**Re: Section 4.55(2) Modification to Development Application DA-723/2021
17 BRYANT STREET, PADSTOW**

The proposal before Canterbury-Bankstown Council seeks to modify approved Development Application No. 723/2021 under the provisions of Section 4.55(2) of the Environmental Planning and Assessment Act, 1979.

Figure 3: Modified ground floor Plan (Prepared by Architects Becerra)

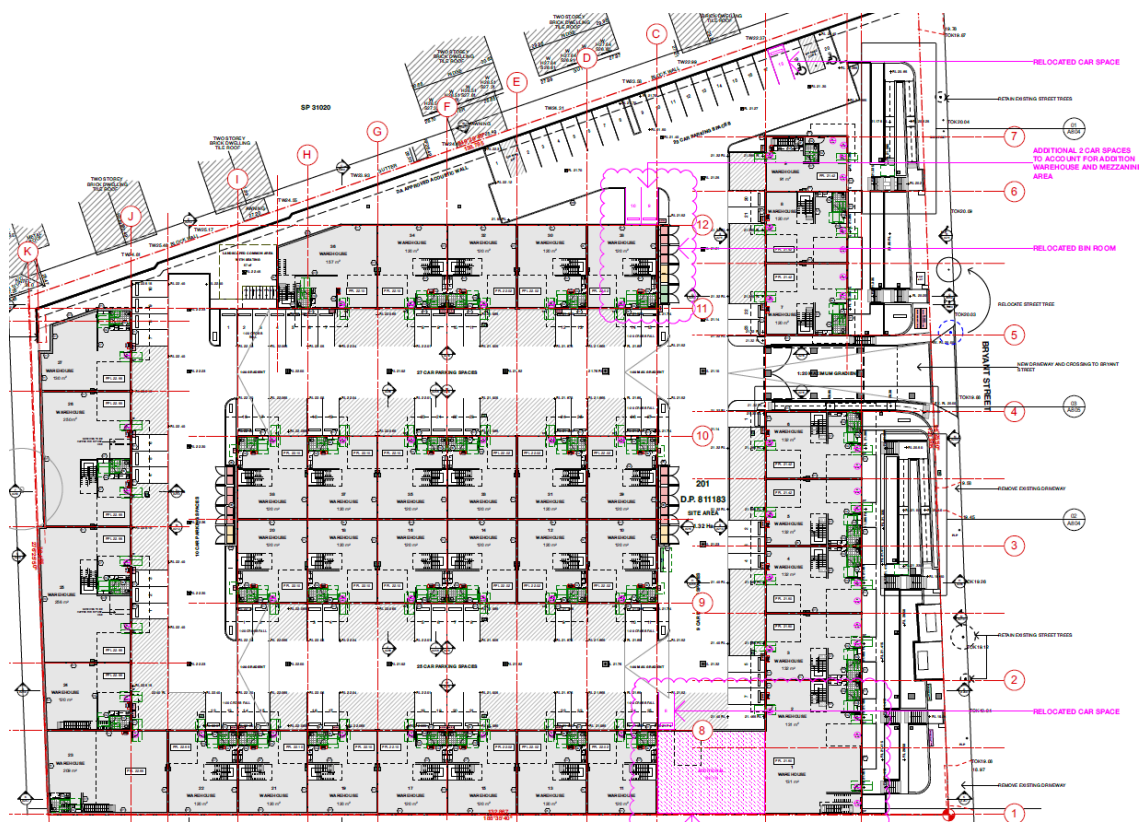
- Merging of Warehouse Units 1 and 2:
 - Reduction in the number of Units from thirty-eight (38) to thirty-seven (37).
- Reconfiguration and reduction to GFA to Unit 27 in the south-western corner;

- Modifications to Warehouse Unit 1:
 - Additional 190m² ground floor area to Unit 1 extending south;
 - Removal of the office approved on the northeast corner of Unit 1;

- Built form between Unit 1 and Unit 11 is now connected;
 - Additional 127m² mezzanine area connecting the mezzanines of Unit 1 and former Unit 2;
 - Reduced north-facing windows;

An excerpt of the proposed modifications to the ground floor, illustrating the merging of two units into one, and an increase to the size of this unit by infilling the space between Units 1 and 11 is provided below, in Figure 3.

Figure 4: Extract of Modified North Elevation, Units 1-6 (Prepared by Architects Becerra)

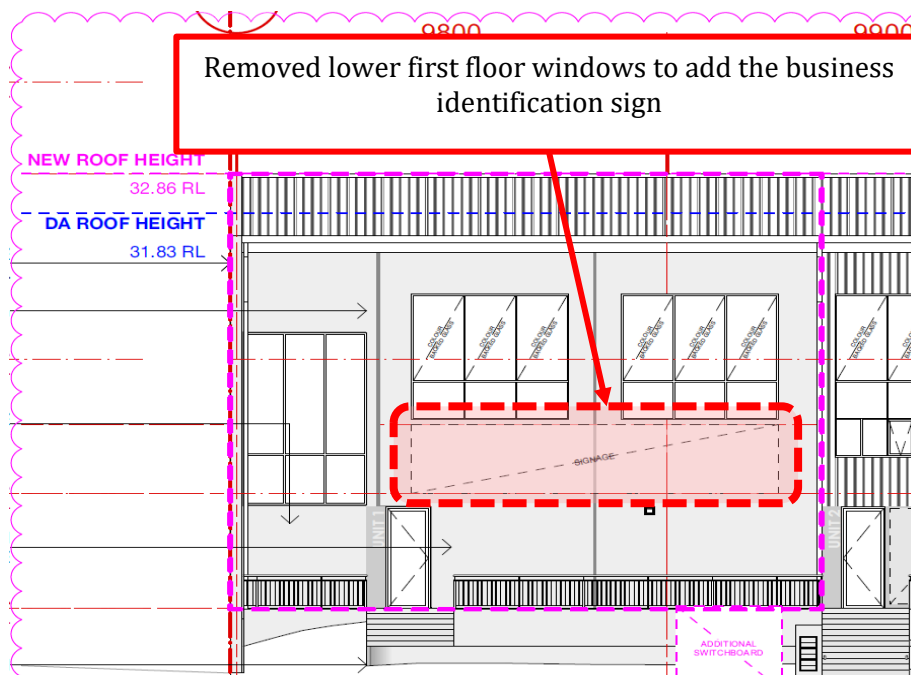
The modification proposed one (1) additional wall sign on the northern elevation of Warehouse Unit 1 as circled in red below:
